**DUBLIN CITY COUNCIL SUBMISSION**

**DESCRIPTION: DART + SOUTHWEST ELECTRIFIED  
HEAVY RAILWAY ORDER  
(HAZELHATCH & CELBRIDGE STATION  
TO HEUSTON STATION, AND HEUSTON  
STATION TO GLASNEVIN).**

**Applicant: CORAS IOMPAIR ÉIREANN**

**ABP CASE REF: NA06S.316119**

Figure 1: Extract from Works Layout Plan No. 10 submitted with DART + South West Railway Order. Sites 4 and 5 are being progressed for housing development by LDA & DCC highlighted in dotted red.

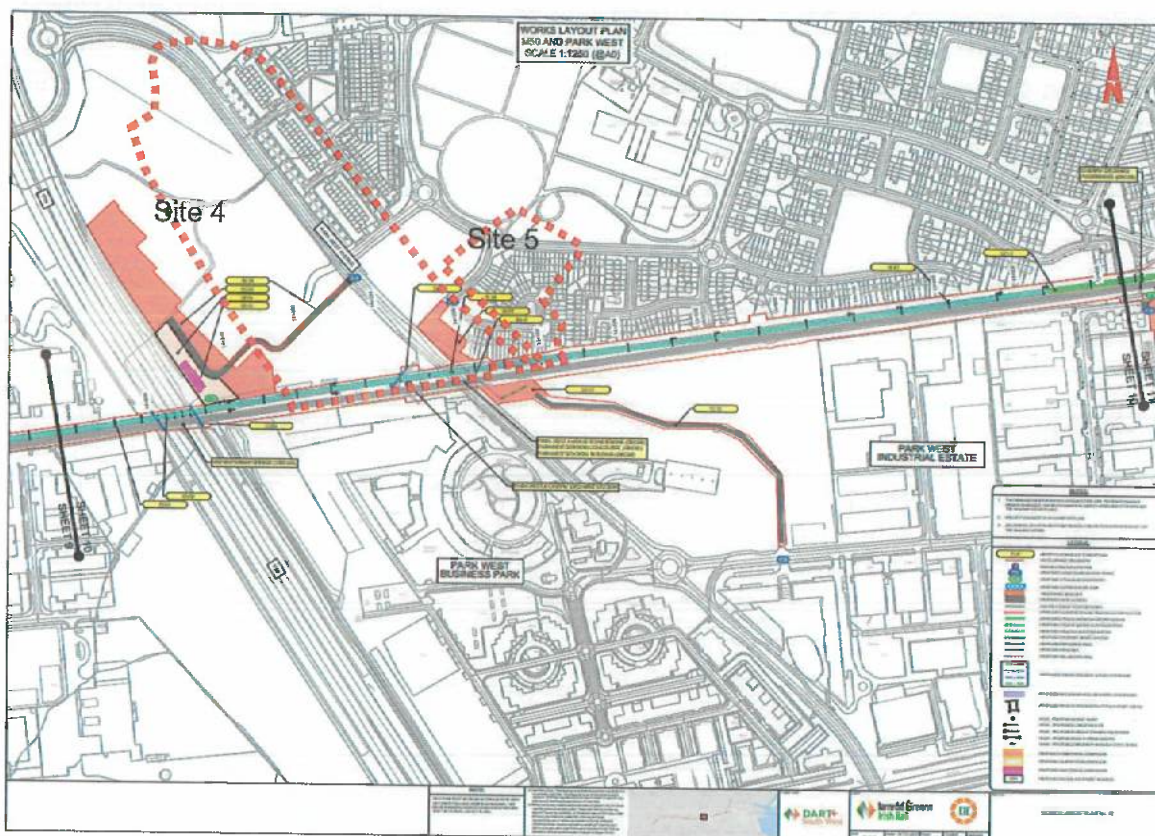
Works Layout Drawing No. 10 submitted with the RO shows several proposed works on the DCC/LDA Site 4. A proposed temporary construction compound is proposed along the west/south-west boundaries of Site 4 (Works No. 10.06). It is proposed that the temporary compounds will be required for the duration of the construction works/programme i.e. until 2029.

DCC requests that further consultation be carried out between DCC, LDA, & CIÉ before and during the construction process to ensure the location of the temporary compound is

Figure 3: Extract from drawing submitted with DART + South West (Drawing title Park West Substation Location Plan and Layout - DP-04-23-DWG-RO-TTA-18856). Only a short section of electricity supply routing is shown on the drawing (terminating at the 'X' denoted by LDA).

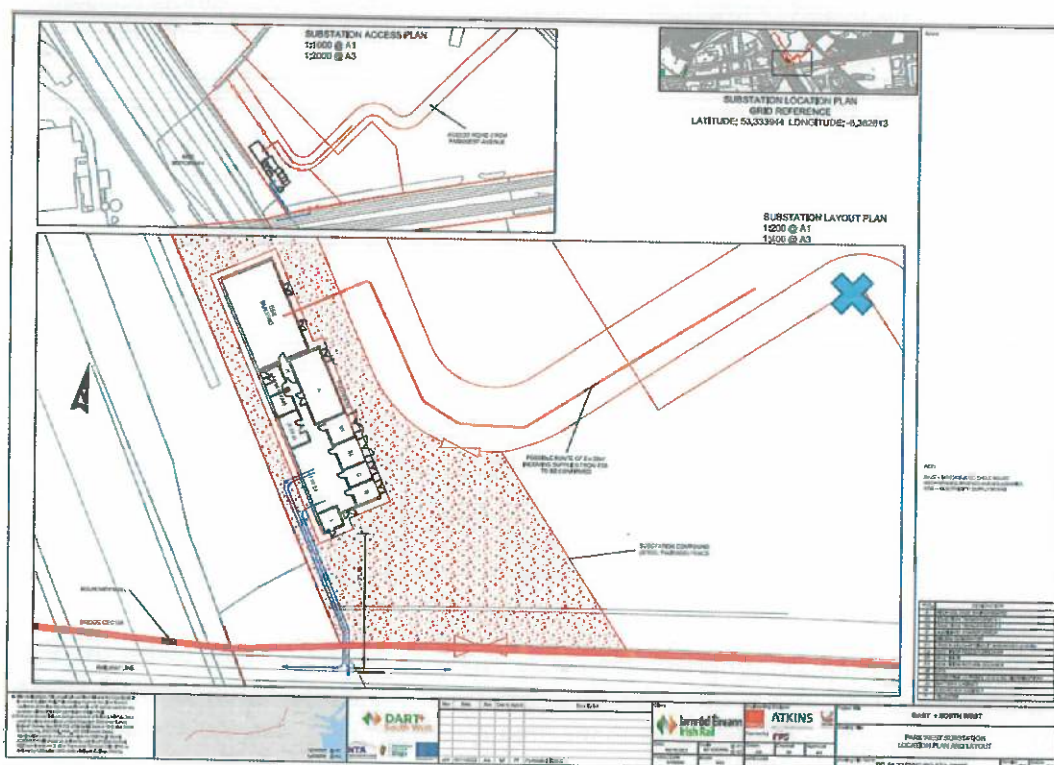
Works Layout Drawing No. 10 submitted with the RO shows a proposed gravel access road to service the Park West Substation Compound and temporary construction compound. The road is to include the substation electricity cable supply (38KV infrastructure) route (Works No. 10.14). The proposed road and cable route follows the line of the proposed permanent development internal road network proposed as part of the forthcoming Phase 1 planning

application at Site 4 proposed by the DCC and the LDA. Given this proposed internal road will be subject to a forthcoming planning application, DCC is seeking to ensure that further engagement with CIÉ and other necessary stakeholders is ensured throughout the construction period. DCC seeks to ensure that the location and routing of the proposed temporary access road and cable infrastructure route be coordinated between all relevant stakeholders to ensure both the DART + and residential-led development at Site 4 can proceed without conflict.

On behalf of DCC and the LDA, Waterman Moylan, Consultant Engineers, have reviewed the information submitted with the RO and understand the 38KV substation proposed on Site 4 to serve the Project will require a two-circuit network connection. The drawings submitted show the proposed substation to the southwest of Site 4 at Park West and only a short section of ducting which is noted as a "possible route of 2 x 38KV incoming supplies from ESB – To Be Confirmed" (See Drawing title Park West Substation Location Plan and Layout - DP-04-23-DWG-RO-TTA-18856). The ongoing route of the 38KV infrastructure will likely have to be provided through the DCC lands (Site 4) to extend as far as Park West Avenue. Furthermore, it would also suggest that additional ducting will have to be provided through existing roads beyond the ownership of CIE/Irish Rail. Waterman Moylan understands a twin circuit 38KV duct cross-section will require a 900mm wide and 1200mm deep service trench through which other services will not be allowed to run (see an example of a service trench below in Figure 4). Other services may run alongside the 38KV twin circuit cross-section, however. The LDA would request that the final alignment of the proposed electricity infrastructure routing follow the proposed road centreline to minimise the impact on and allow space for the additional necessary infrastructure to serve the overall development of Site 4.

Figure 5: Proposed planting options for substation boundary proposed by DCC and the LDA.

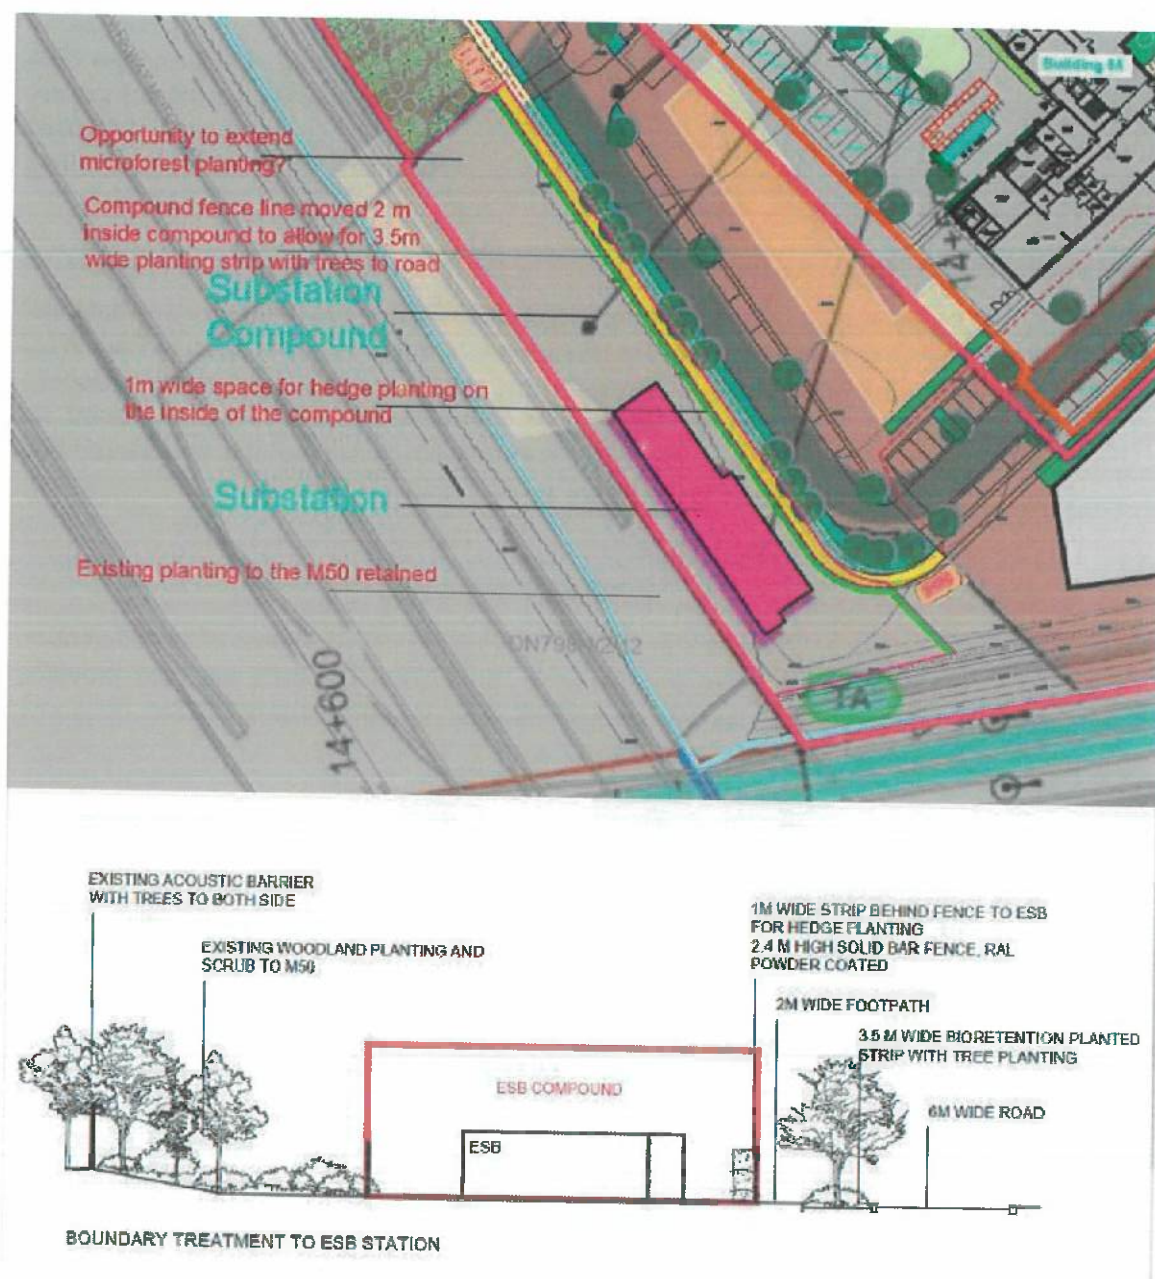
DCC wishes to make several comments regarding the proposed substation and permanent compound. Presently, the existing tree planting along the M50 within Site 4 provides a landscaped buffer to the site. The LAP also seeks a 'green buffer zone' along this boundary with the M50 as part of a 'green corridor'. The proposed substation will permanently remove some of the existing trees and hedgerows.

DCC would request that some form of permanent tree and/or landscape planting be proposed either outside or inside the eastern and north-eastern boundary fences of the substation to ensure a landscape buffer is provided to Site 4. This will ensure the green buffer is provided as sought by the LAP and will mitigate the visual impact of the substation which will in future be located opposite housing and commercial development at Site 4. The following options are suggested (see Figure 5 for illustration):

Option 1: Consider moving the proposed boundary palisade fence 2 metres inside the ESB compound on the eastern side to allow for the widening of the bio-retention planting strip to 3.5 metres to accommodate tree planting to mitigate the visual impact of the compound and loss of existing trees in that zone.

Option 2: If no opportunity for planting within the compound area, consider at least a 1 metre-wide planting space along the fence line to the inside of the compound to allow for hedge planting (hedge to be planted on the inside of the compound to prevent people from climbing on the hedge and over the fence).
